**0013** Technical Service Information**Subject:** Cylinder head gaskets**Relates to:** 61-34162-00 / -10**Make:** Opel**Model(s):** Agila, Astra, Corsa**Engine code:** X 12 XE, Z 12 XE**Repair thickness CHG 1.2 Opel
Ecotec X 12 XE / Z 12 XE**

Figure_Cylinder head gasket, Reinz no. 61-34162

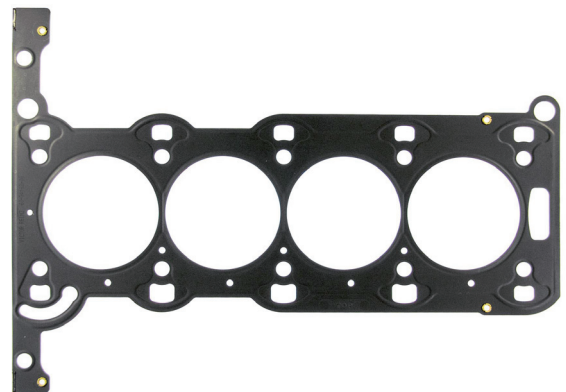
With the new exclusive repair thickness for the Cylinder Head Gasket 61-34162-00 = Opel 56 07 448, Dana offers the perfect solution for reliable sealing of reworked cylinder heads and cylinder blocks.

The repair thickness is 0.25 mm thicker than the original. After necessary surface machining, this thickness thus offers best sealing results up to this measurement.

The order number for the repair thickness is **61-34162-10**.

Caution: After the cylinder head and cylinder block have been machined, the surface roughnesses must be in a tolerance band between 7 µm and 20 µm. The waviness value should not exceed 20 µm.
